Attachment No. 8 Tully and Young Peer Review Report, December 1, 2014

Final Summary Analysis and Conclusions for the Peer Review of *Hydrogeologic Evaluation of Current Groundwater Conditions at the CEMEX Stillwell Quarry* (prepared by EMKO, February 26, 2014)

Prepared for: County of Tulare Resource Management Agency

То:	Michael C. Spata, Director Tulare County Resource Management Agency
From:	Greg Young, P.E.
Date:	December 1, 2014
Subject:	Final Summary, Analysis and Conclusions

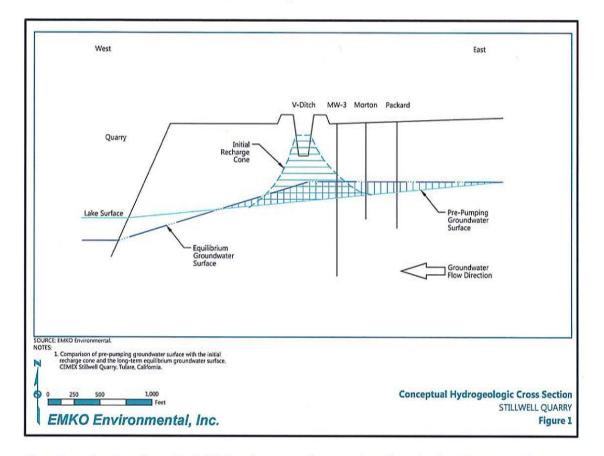
The Oct 29 Memo states that for either mechanism to occur, groundwater surface must slope downward from the private wells to the excavation and continues by comparing the Morton well elevations to those in MW-3. The Oct 29 Memo asserts that MW-3 must be "consistently lower than the level in the Morton well" (Oct 29 Memo, p. 2) for either mechanism to occur, then demonstrates that groundwater elevations in MW-3 are consistently higher than the Morton well (with a few noted exceptions) – thus the mechanisms do not occur. The following explains the inaccuracies in this analysis.

As required by the Conditions of Approval (Conditions), the Quarry shall construct a "V" ditch that "shall contain a sufficient amount of water in order to establish a groundwater mound (groundwater barrier) to maintain water levels in neighboring wells." (Condition #55). As illustrated by EMKO in Figure 1 accompanying the Oct 7 Memo (see below, and Attachment 2), the water discharged to the "V" ditch creates a mound.

Because of the immediate proximity of the monitoring wells to the "V" ditch, the elevations in the monitoring wells will reflect the fact that water is percolating into the ground from the "V" ditch – as defined by the soil's characteristics between the "V" ditch and the monitoring well.

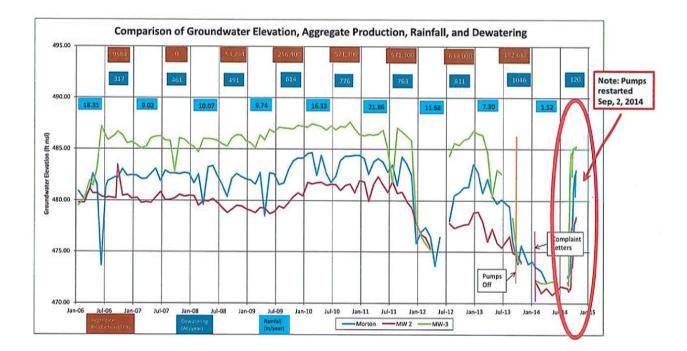
3. The Oct 30 Memo does not discuss the immediate recovery of groundwater elevations that are evident on the right-hand side of the graph. These elevation increases are directly related to restarting discharges to the "V" ditch on September 2, 2014. The figure below is from the Oct 30 Memo, with the right-hand data circled. The relevance of the immediate recovery of groundwater elevations in the monitoring wells and private wells appears to indicate an important correlation between pumping to the "V" ditch and the ability to "maintain water levels in neighboring wells." (Condition #55).

- 4. The Oct 30 Memo appears to assert there is a correlation among the volume of dewatering, aggregate production, rainfall and groundwater elevations, yet none are defined nor are any readily drawn from the presented data. For instance, the volume of dewatering does not relate to the volume of aggregate production or rainfall quantities. In another example, groundwater elevations remain relatively stable from 2006 through 2011 even with significant variations in rainfall (e.g. 2007 had 9 inches and 2011 had nearly 22 inches while groundwater elevations only appear to vary by a few feet). The purpose of including some of this data is unclear.

FIGURE - Fig 4.4-2 from an old (?) version of the DEIR.

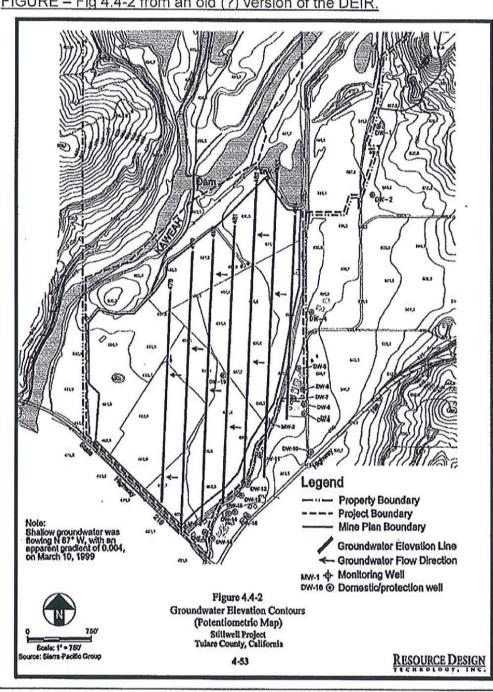
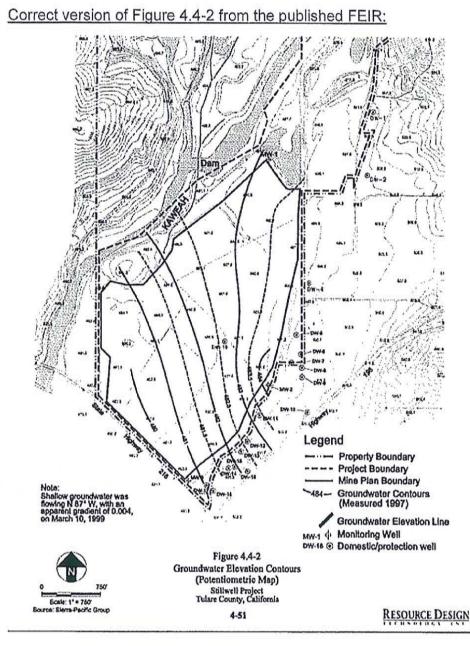
5. Figure 4.4-2 presented in the 2002 EIR (EIR p. 4-53) graphically represents the groundwater flow direction as east to west across the Quarry to the River, with no flow coming from the River from the northern area. A copy of this figure is included below. The figure presented within the text of the Peer Review does not appear in either the 2002 EMKO hydrology report (included as Attachment 7 to the Peer Review) or in the 2002 Revised DEIR. The County has apparently provided T&Y with an incorrect draft version of the published EIR and accordingly the evidence discussed here in the Peer Review is incorrect. The two different versions of the figure are presented below for comparison. The first figure is the incorrect version relied upon by T&Y, while the second figure is the one that appears in the Revised DEIR which is included in Part B of the June 2002 FEIR.

As is very apparent from the analysis in 2002, the River does not contribute recharge to the aquifer. This is incorrect. The 2002 analysis did not specifically address this issue and does not provide any data that could lead to this conclusion. However, during preproject conditions, it likely had an influence on the hydraulic gradient and flow conditions that underlay the subject properties – essentially a mounding affect. The data and analysis presented in the 2002 hydrology report and the 2002 Revised DEIR are completely contradictory to the speculative conclusion presented in this sentence of the Peer Review regarding the Kaweah River having a mounding effect. The river acts as a drain, with water from the Stillwell site discharging
